Bay du Nord Development Project

Environmental Impact Assessment (Draft)

Response to Regulatory Review Information
Requests

**Bay du Nord Development Project
Environmental Impact Statement (draft)
Response to Regulatory Review Information
Requests (CEAR 80154)**

Figure 15-2 Special Areas and Oil and Gas Activities Offshore Newfoundland
 Legend for Figure 15-2

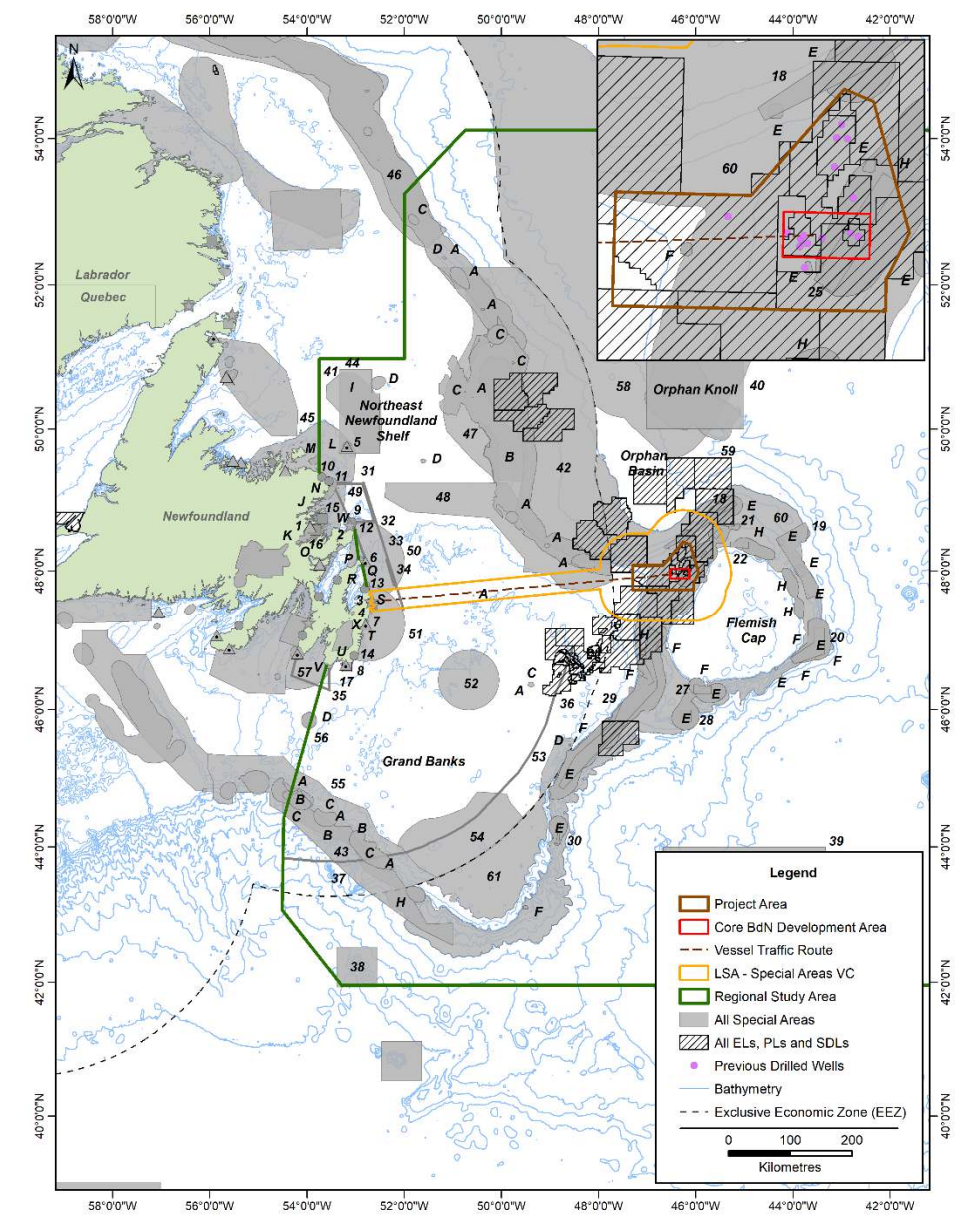
conducted by NAFO. This information is important to clearly understand the existing environment in the assessment of effects.
Request 15-Apr-19	Incorporate overview map showing licences, Project Area, Sensitive Benthic Areas, fishing closures and Vulnerable Marine Species work conducted by NAFO.

Equinor Response 15-Nov-19	The following figure will replace Figure 15-2 in the EIS.
---------------------------------------	---

Figure Error! No text of specified style in document. 6-42 Atlantic Salmon Research Vessel Catches in the Northwest Atlantic Ocean (1965 to 1985)
--	--

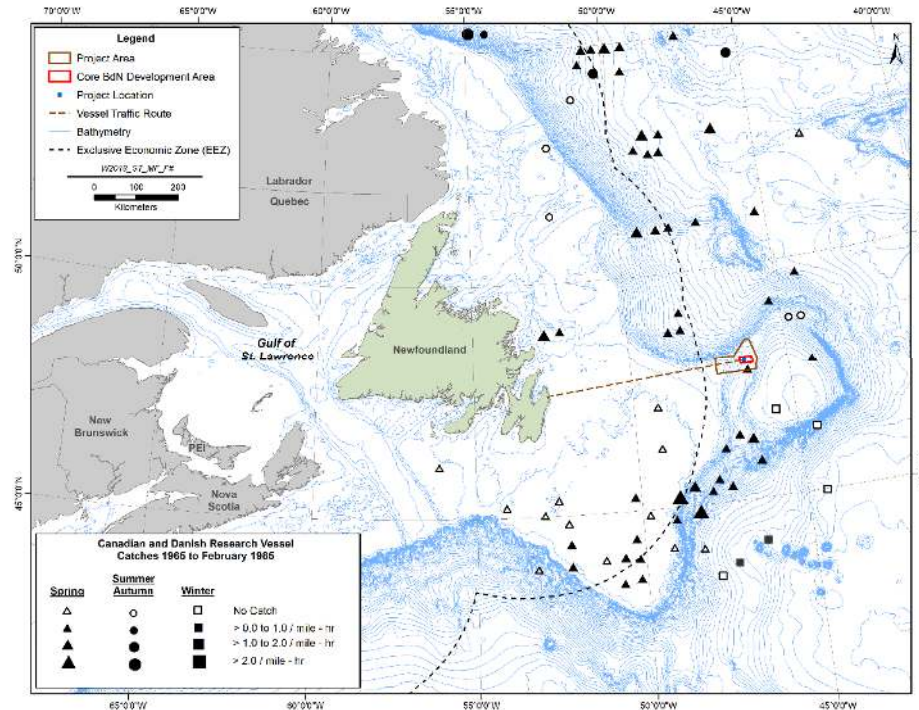
<p>IR-96 DFO-28</p>	<p>Guideline Ref: Part 2, Section 7.1.3</p>	<p>EIS Ref: Section 6</p>
<p>Context/Rationale</p>	<p>Inconsistencies are noted in Section 6.0 of the EIS.</p> <ul style="list-style-type: none"> • In contradiction to the text (Page 6-14), Chl a concentrations appear higher south of the Flemish Cap and southeastern sections of the Grand Banks and are generally heightened in spring relative to winter based on Figure 6-4. • Inconsistencies are noted between the text (Page 6-19) and associated figures (Figures 6-5 and 6-6) for northern shrimp. Years of the surveys are different. The text indicates that northern shrimp were sampled in the Project Area; however Figure 6-6 does not show any catch in the Project Area. • The statement “In the Project Area, shrimp species were numerically dominant in the Project Area based on Canadian RV surveys. However, the abundance in the Project Area is relatively low compared to captures on the Northeast NL Shelf (Figure 6-5)” (Page 6-62); is inconsistent with Figure 6-5, which only depicts Northern Shrimp. • The statement that roughhead grenadiers have “relatively low abundances inside the Project Area” (Page 6-87) is inconsistent with Figure 6-21. • The spawning description for Greenland Halibut (Page 6-84) is inconsistent with Table 6.30. • The statement “northern wolffish had the highest abundance of the three species based on Canadian RV surveys” (Page 6-117) is inconsistent with Figures 6-35 to 6-37, which suggest that striped wolffish are the most abundant. • The statement “Sampling near the Flemish Pass in winter and summer/autumn captured no salmon (Reddin and Shearer 1987)” (Page 6-130) is confusing given that sampling did not appear to occur near the Flemish Pass during winter in Figure 6-42. <p>This information is important to accurately describe the marine fauna and habitats to assess environmental effects of the Project.</p>

Reddin and Shearer (1987) conducted winter sampling in the southern Flemish Pass. Figure 6-42 will be updated to reflect the winter sampling and is as follows:

Figure 6-69 Canadian Marine Protected Areas and Marine Refuges in the RSA

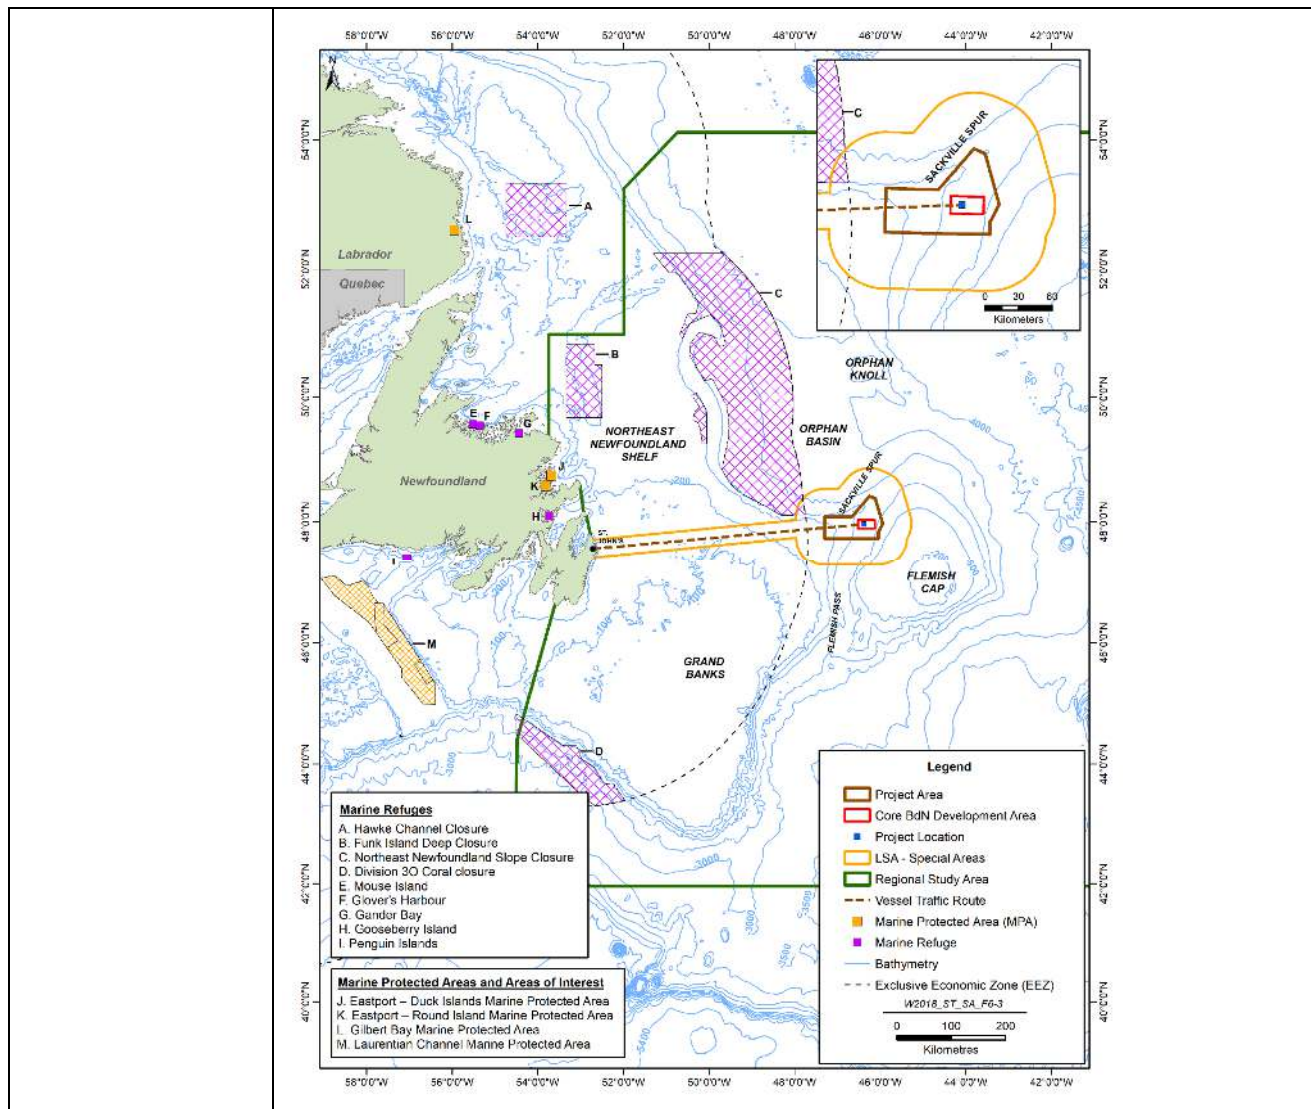
<p>B. Table 6.58 in the EIS should include all of the Marine Refuges located in the RSA.</p> <p>C. Figure 6-69 in the EIS should display all of the marine refuges located within the geographic scope of the map.</p> <p>D. Include the Division 3O Coral Closure wherever Marine Refuges are described as located in the RSA throughout this EIS, including figures and tables.</p> <p>E. Update the effects analysis, as appropriate</p>																												
<p>Equinor Response 15-Nov-19</p>	<p>A. See response to IR-191/DFO-54 Part A.</p> <p>B. Table 6-58 will be amended to include the 3O Coral Closure area and the Lobster Area Closure: Gooseberry Island.</p> <p>Table 6.58 Marine Refuges in the RSA</p>

<p>Source: DFO (2019).</p> <p>A. Figure 6-69 will be amended as follows:</p>	Marine Refuge	Rationale for Identification / Designation	Distance to Special Area (km)			CBDN	PA	LSA	Northeast Newfoundland Slope Closure (formerly known as Tobin's Point)	Dense aggregations of large, structure-forming cold-water corals provide niche space for other organisms. Prohibitions for bottom contact fishing activities. Area: 46,833 km ²	92	34	Intersect	Funk Island Deep Closure	Conserves seafloor habitat important to Atlantic cod. Bottom trawl, gillnet and longline fishing activities are prohibited. Area: 7,274 km ²	475	420	214	3O Coral Closure	<i>All bottom fishing activities are prohibited to protect concentrations of corals and sponges: fragile slow-recovering species that form habitat structure for other species. Area: 10,422 km²</i>	646	588	321	Lobster Area Closure: Gooseberry Island	<i>Lobster fishing is prohibited to protect lobster spawning habitat and increase egg production for this commercially important species.</i>	538	480	89
Marine Refuge	Rationale for Identification / Designation			Distance to Special Area (km)																									
		CBDN	PA	LSA																									
Northeast Newfoundland Slope Closure (formerly known as Tobin's Point)	Dense aggregations of large, structure-forming cold-water corals provide niche space for other organisms. Prohibitions for bottom contact fishing activities. Area: 46,833 km ²	92	34	Intersect																									
Funk Island Deep Closure	Conserves seafloor habitat important to Atlantic cod. Bottom trawl, gillnet and longline fishing activities are prohibited. Area: 7,274 km ²	475	420	214																									
3O Coral Closure	<i>All bottom fishing activities are prohibited to protect concentrations of corals and sponges: fragile slow-recovering species that form habitat structure for other species. Area: 10,422 km²</i>	646	588	321																									
Lobster Area Closure: Gooseberry Island	<i>Lobster fishing is prohibited to protect lobster spawning habitat and increase egg production for this commercially important species.</i>	538	480	89

- B. Division 30 Coral Closure Marine Refuge will be included in Figure 6-69. Refer to Part C above
- C. Distances and intersections have been calculated for the updated Marine Refuges in the RSA. No Marine Refuges intersect the Core Bay du Nord Development Area or the Project Area. The addition of this information will not result in changes to the conclusions of the EIS.

Figure 1. Panels A & B: Concentration of a theoretical constituent under low current speed (A) and under high current speed (B). Panels C & D: PEC/PNEC under low current speed (C) and under high current speed (B).

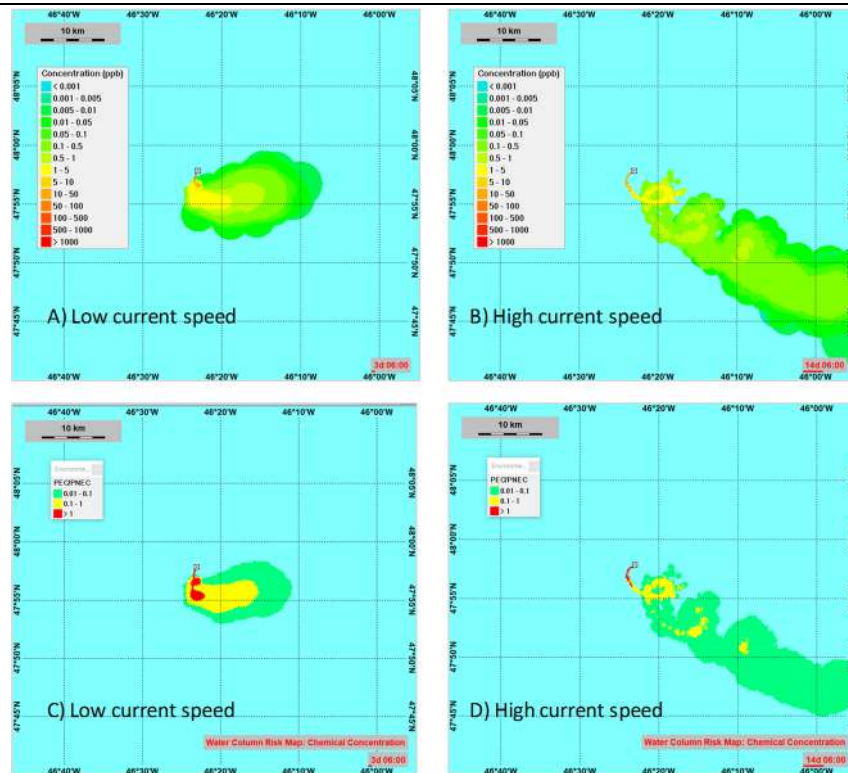
As noted above, the reviewer raises questions concerning the potential for currents to cause the plume to disperse further. Using June currents, the following figure shows concentrations of a theoretical constituent over the entire modelled area at low current speeds (Figure 1, panel A below) and at high current speeds (Figure 1, panel B below). Panel C and D of the figure also show predicted environment concentrations (PEC) over predicted no-effects concentrations (PNEC) for this theoretical constituent. Where $PEC/PNEC > 1$, cells are over the no-effects threshold. It is true that the plume extends further at higher current speed (compare panels A and B). However, the area over threshold is smaller (compare the red area in panels C and D). Even if distance from source rather than total area was considered, cells over threshold extend to approximately 6 km from source at low current speeds, while cells over threshold at faster current speeds extend to approximately 4 km. We reiterate that this is a theoretical example. Discharge concentrations were high, and the no-effects threshold was low, to provide a clear example.

Figure 2. Number of cells over threshold for a theoretical constituent over the 30-day modeling window.

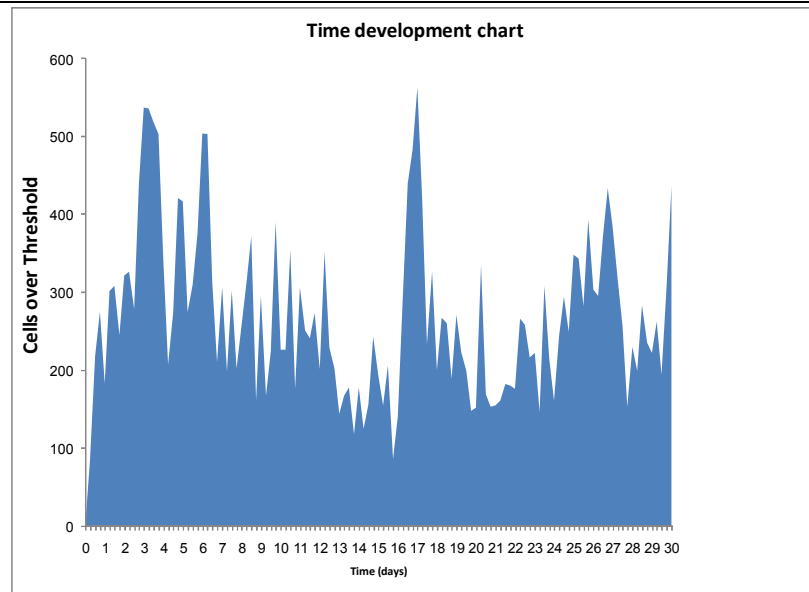
During the Regulatory Review Workshop, concern was also noted about modelling a single month, rather than 1 year or 30 years. What is presented in Appendix J is the probability that cells will exceed threshold relative to distance from source. As noted in the Appendix, this is calculated as the number of model outputs above threshold in that cell over the total number of outputs in a 30-day simulation X 100. It is demonstrated above that faster currents decrease concentrations. Therefore, including the remainder of the year, and faster currents, would decrease these probabilities, again illustrating that using the slower current month is the most conservative approach. Finally, unlike sediments, there is no long-term accumulation of constituents in the water column. If this was the case, then the number of cells over threshold would generally increase over the course of even a 30-day simulation. This is not the case. Concentrations do increase during the first few model time-steps but, as can be seen from Figure 1, higher concentrations occur on day 3 and lower concentrations occur on day 14. This is also shown in Figure 2 below, showing the number of cells over threshold for this theoretical constituent over the course of the 30-day simulation window. There is no increasing trend in the number of cells over threshold.
